## **DECLARATION STATEMENT - RECORD OF DECISION**

### **Dewey Loeffel Inactive Hazardous Waste Site Operable Unit 2 Town of Nassau, Rensselaer County, New York Site No. 442006**

The Proposed Remedial Action Plan (PRAP) for the Dewey Loeffel Site was prepared by the New York State Department of Environmental Conservation (NYSDEC) and issued to the local document repository on November 8, 1999. This Plan outlined the preferred remedial measure proposed for the remediation of the contaminated soil and sediment at the Dewey Loeffel site. The preferred remedy is Alternative 9, Disposal Site Hydraulic Containment with Downgradient Groundwater Recovery and Treatment.

This Responsiveness Summary responds to all questions and comments raised at the November 30, 1999 public meeting and to the written comments received.

Attachment 3

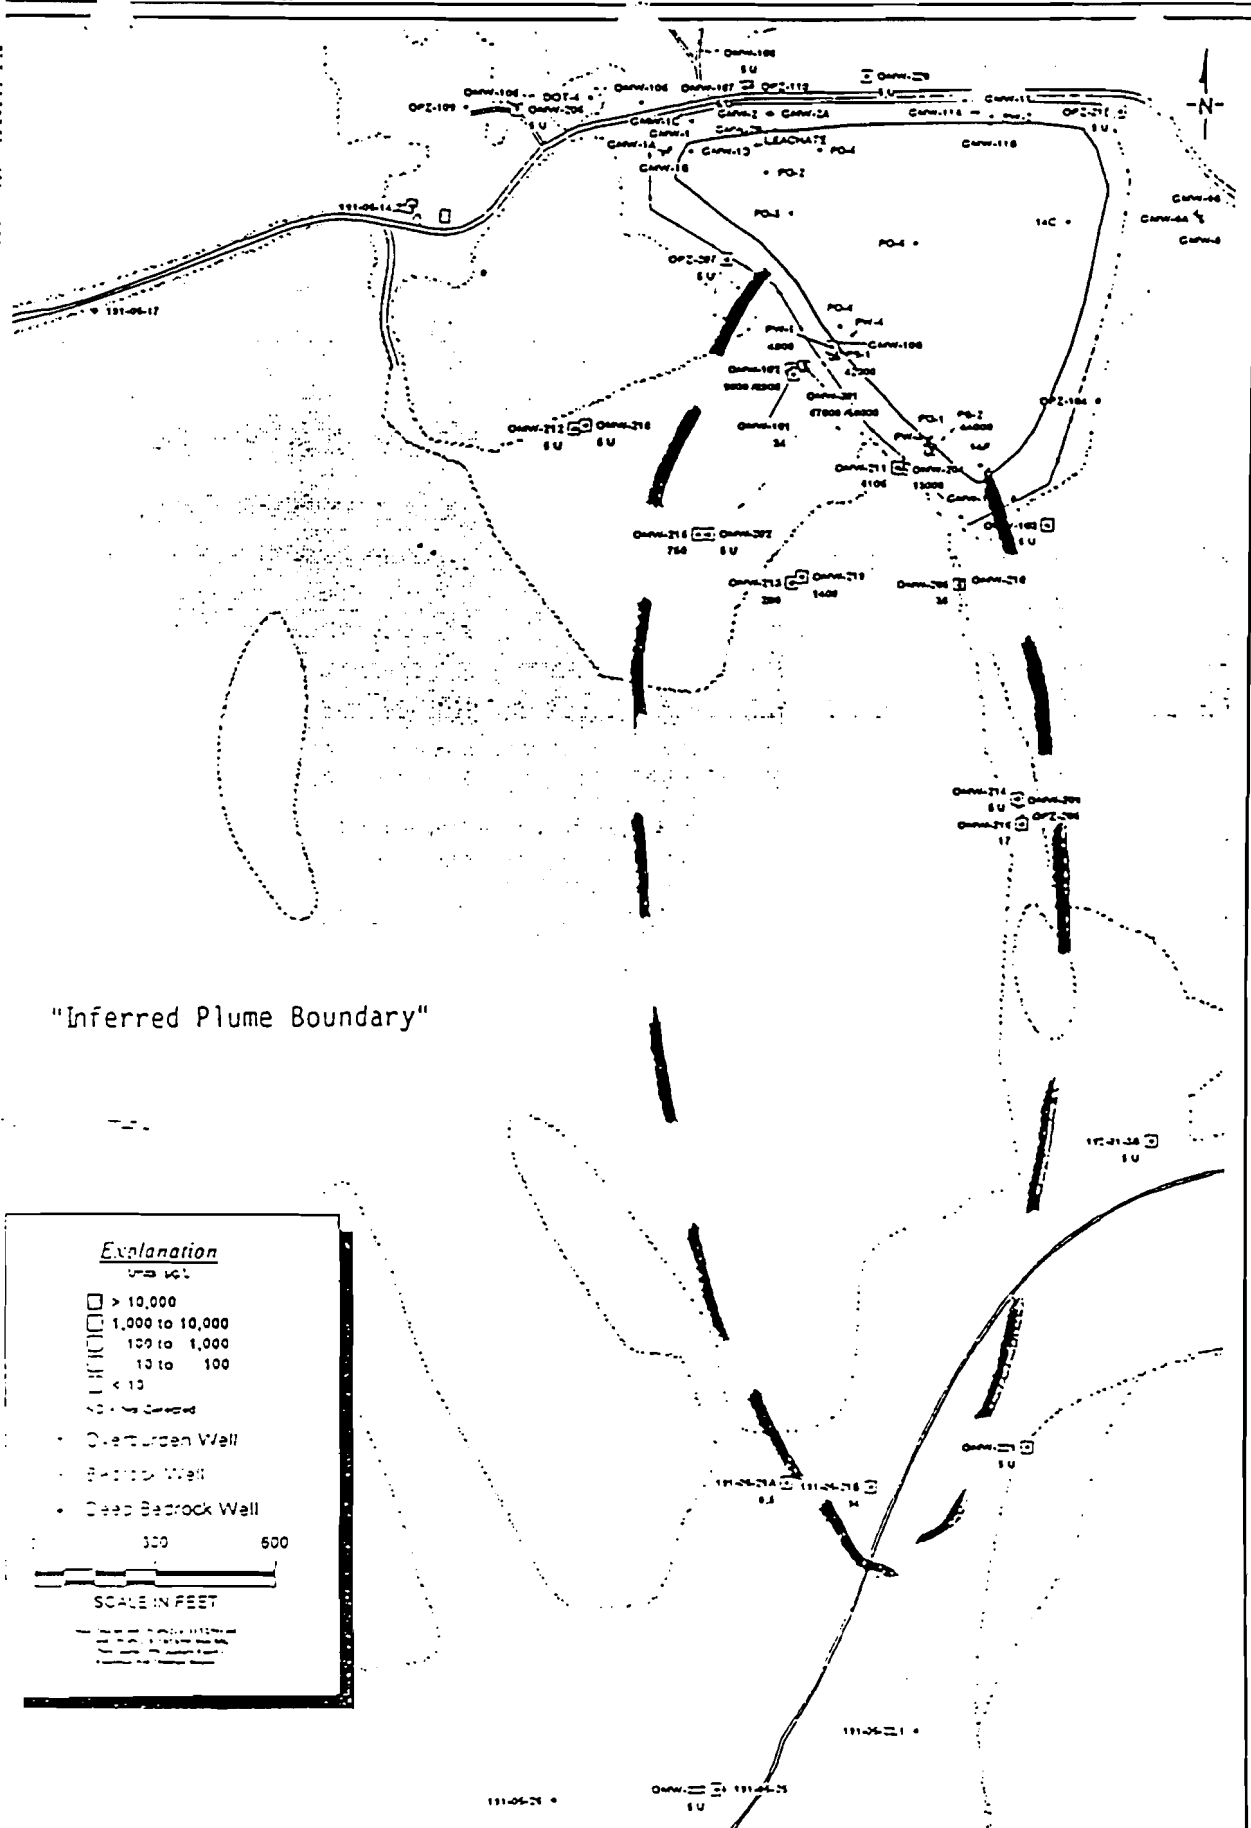
**Comment RCEMC-6:**

This information is available in the RI/FS reports at the document repositories. Two figures depicting the potential zone of influence have been added. See Attachment 3.
